# FLORIDA DEPARTMENT OF ENVIRONMENTAL PROTECTION

## Final TMDL Report

**Pensacola Bay Basin**  
**Judges Bayou Marine (WBID 493B)**  
**Judges Bayou Freshwater (WBID 493A)**  
**Bayou Chico (WBIDs 846 and 846C)**  
**North Escambia Bay (WBID 548AA)**

### Public Comments and Department Responses

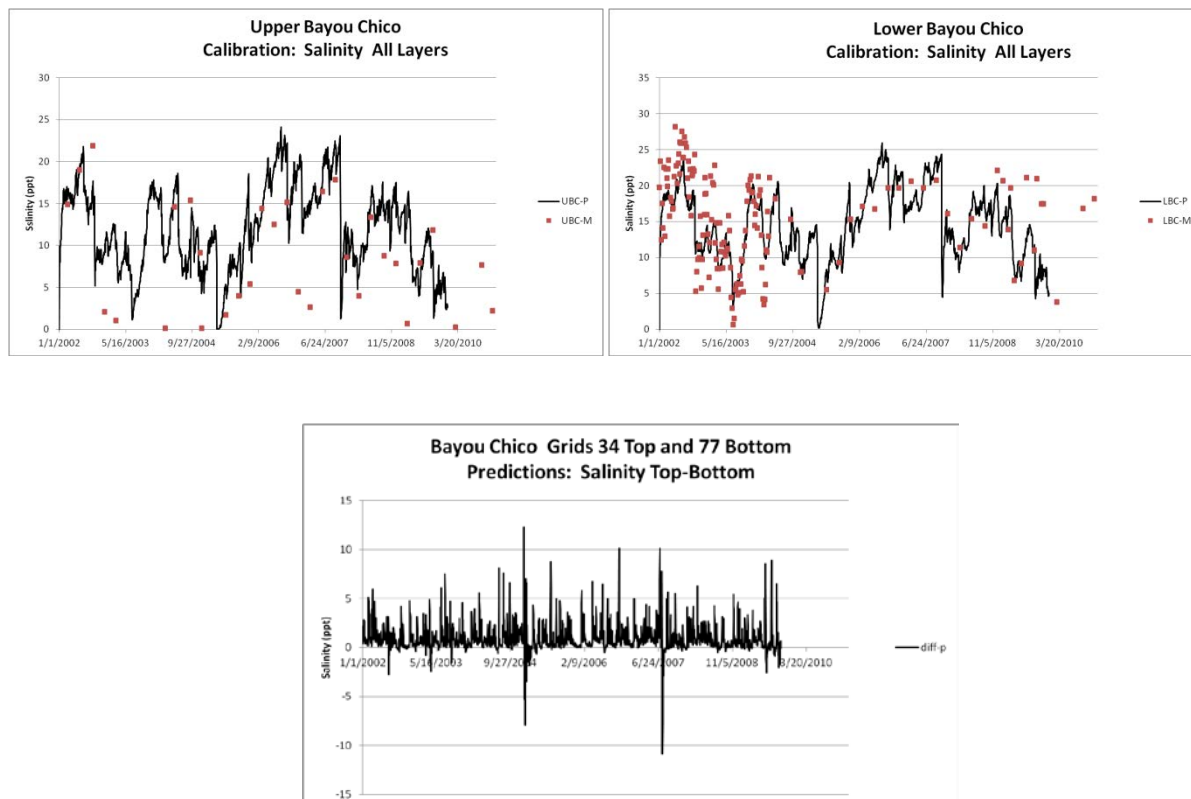
The model grid of the receiving waters used in the EFDC hydrodynamic model and the WASP water quality model significantly misrepresents the system geometry. The quality of the physical representation is so poor that it makes any hydrodynamic or water quality inferences from the model unusable.

We agree that the GIS grid representation for the geometry of the waterbody (model grids) does not match the waterbody geometry in several areas. It is our understanding from EPA that within the EFDC input deck the actual geometry used by the models is more representative of

the waterbody. FDEP will work with EPA to provide you this information and to investigate the impact on water movement and water quality from a more refined model grid. In the meantime, plots of salinity predictions from the Upper and Lower areas of the Bayou and of the difference between the top and bottom layers of the model as compared to available data for these areas indicate the EFDC/WASP models are sufficiently representing both the water movement and the magnitude and seasonal changes in the salinity structure of the bayou. The limited paired data for surface and bottom salinities indicate that the model is reproducing the magnitude and seasonal signal of the measured data.

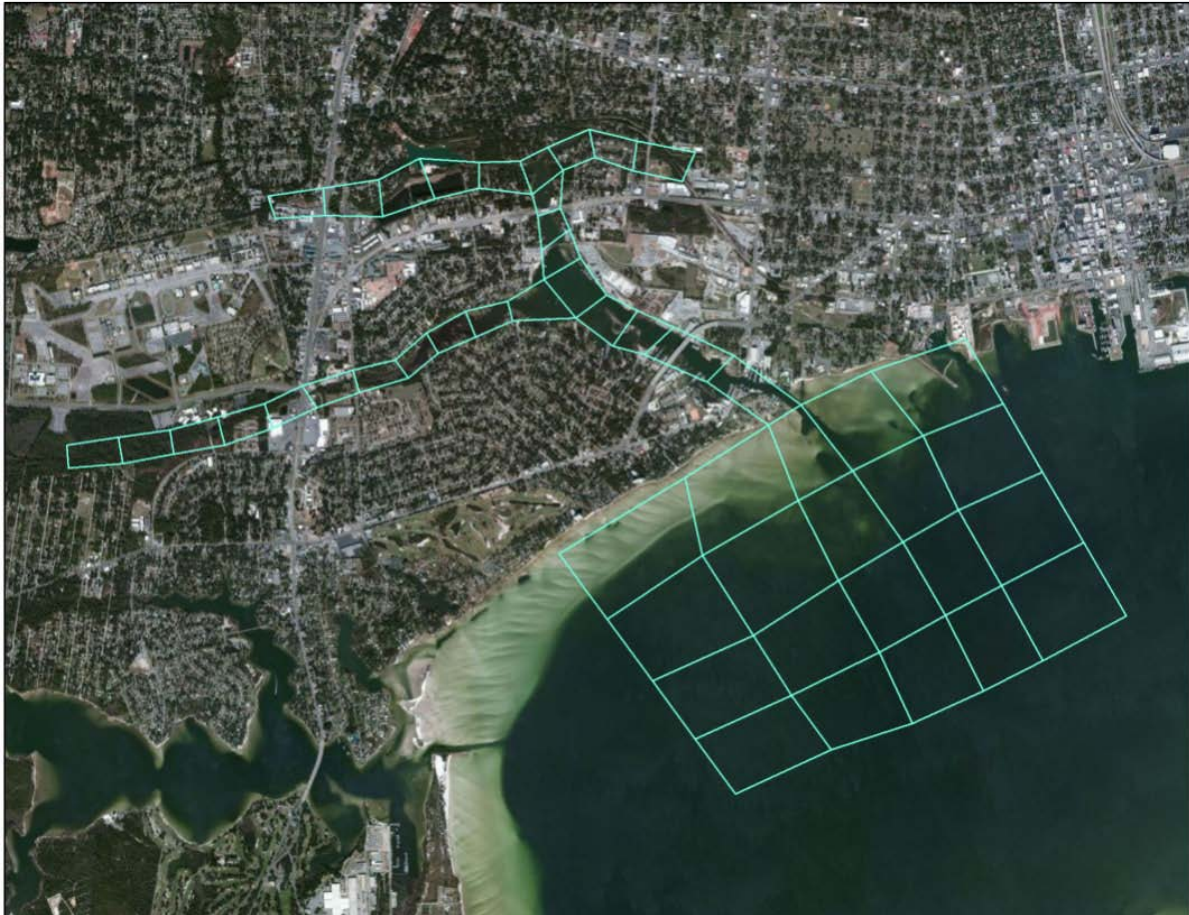
The figure below shows the model grid used for the EFDC and WASP models in Bayou Chico. This representation of the system is not useable. The grid significantly overestimates the entrance from Pensacola Bay into Bayou Chico. It significantly overestimates the surface area of the bay, which is one of the primary factors in the determination of tidal prism. It has widths on the order of hundreds of meters, where the waterbody is only around 10 meters. In model development, the shoreline representation is one aspect that can be accurate. Given the lack of tide data in the interior to assure that the tidal wave is progressing appropriately, an accurate representation of the geometric conditions is critical. This significant amount of error introduced at the starting point for the receiving water modeling makes everything else in the EFDC and WASP models suspect.

We agree that the GIS grid representation for the geometry of the waterbody (model grids) does not match the waterbody geometry in several areas. It is our understanding from EPA that within the EFDC input deck the actual geometry used by the models is more representative of the waterbody. FDEP will work with EPA to provide you this information and to investigate the impact on water movement and water quality from a more refined model grid. In the meantime, plots of salinity predictions from the Upper and Lower areas of the Bayou and of the difference between the top and bottom layers of the model as compared to available data for these areas indicate the EFDC/WASP models are sufficiently representing both the water movement and the magnitude and seasonal changes in the salinity structure of the bayou. The limited paired data for surface and bottom salinities indicate that the model is reproducing the magnitude and seasonal signal of the measured data. Additionally, calibration plots of water quality for temperature, Chlorophyll a (Chla), and nutrients contained in the draft report indicate that EFDC/WASP are sufficiently calibrated to accurately predict the long-term annual average

**Figure 1. Upper Escambia Bay Annual Average Chl-a and Flow Percentile (1973-2009)**  
(FDEP IWR Database Run 45 for WBID 548AA and USGS at Century)

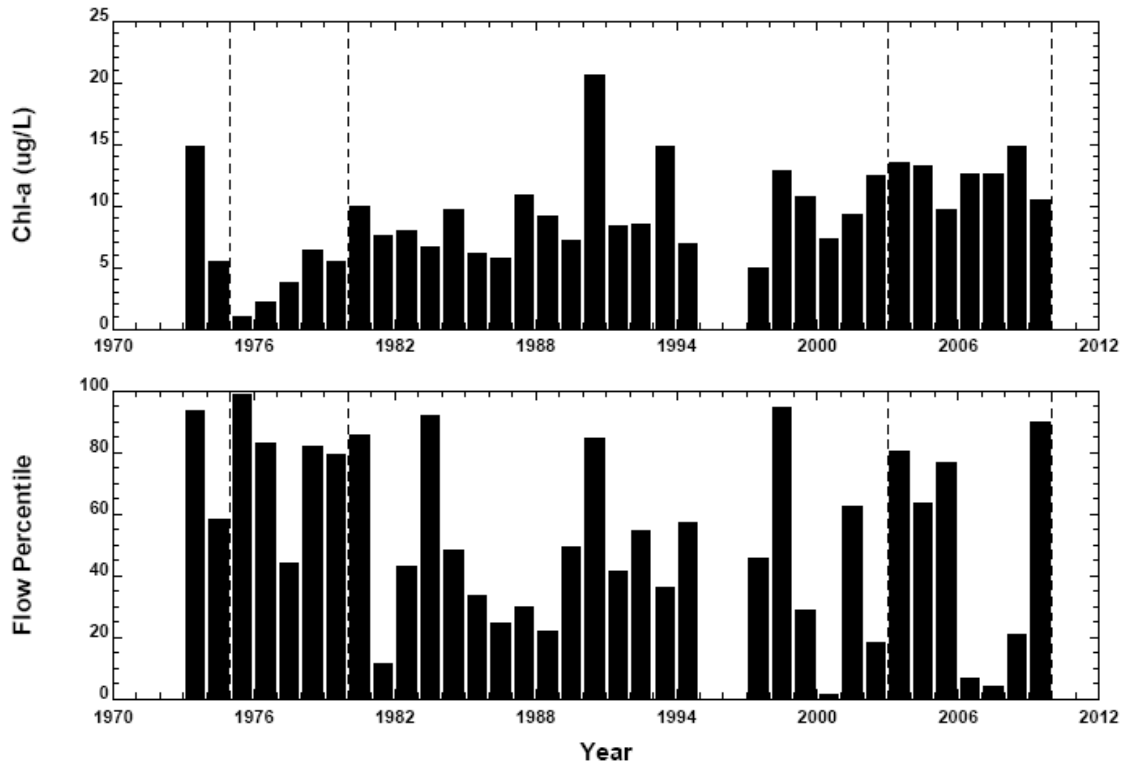
Given, the potential issues with selecting a historic minimum period to set the TMDL chl-a target, we recommend that the TMDL chl-a target be revised based on an approach that considers the health of the bay (DO, light levels, algal blooms, biological data) similar to what we are using to assess nutrient loads with the HDR|HydroQual estuary model.

The target for the TMDL will be to reduce the long-term (2002–09) annual average CChla in WBID 548AA in the FDEP version of WASP from the current level in the calibrated model of 10.07  $\mu\text{g/L}$  to a long-term annual average concentration of less than 7.95  $\mu\text{g/L}$  and to provide for a margin of safety. In addition, as to use of the CChla target of less than 7.95  $\mu\text{g/L}$  in North Escambia Bay, FDEP will utilize other endpoints to assure that water quality standards are met throughout the bay system. These additional endpoints will include DO, light availability, and the potential for algal blooms.

Figure 2. Upper Escambia Bay Chl-a, TN and TP Quarterly Average Data (1970-2011)  
(FDEP IWR Database Run45 for WBID 548AA)

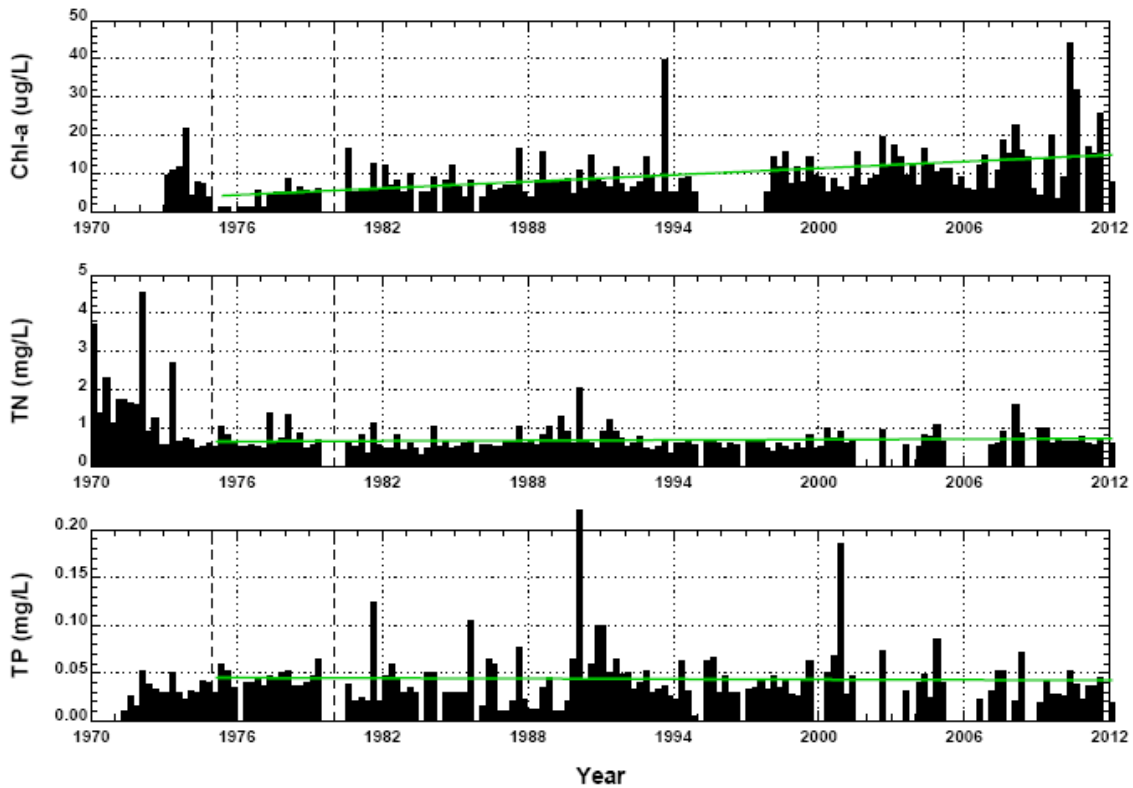
Water quality data from North Escambia Bay (WBID 548AA) are presented in the report to show trends in the chl-*a*, total nitrogen (TN) and total phosphorus (TP) data from the period of record. In order to highlight these trends, FDEP IWR data from Run 45 were extracted from the database and are presented in Figures 2 and 3. Figure 2 presents the North Escambia Bay (WBID 548AA) data and Figure 3 presents data from the lower Escambia River (WBID 10D) to assess nutrient loads to the upper bay. The data in these figures are presented as quarterly

The data from North Escambia Bay show the increasing trend in chl-a data but relatively stable TN and TP levels (i.e., little to no trend). In order to see if nutrient loadings from the Escambia River may be increasing and the potential cause for the increasing chl-a trend, the FDEP data near Molino are presented in Figure 3. The Escambia River data show slightly decreasing or no trends in the chl- a, TN and TP data. Table 1 presents data averages for two periods based on the availability of North Escambia Bay chl-a data (1975-1994 and 1997-2012).

FDEP appreciates the commitment of the stakeholders to work with FDEP and has revised Chapter 7 of the TMDL report to reflect the FDEP commitment to continue working with stakeholders to address the need for any additional studies and model refinements before making detailed allocations to the WLA stormwater and LA components of the TMDL. This approach is pursuant to Paragraph 403.067(6)(b), Florida Statutes.
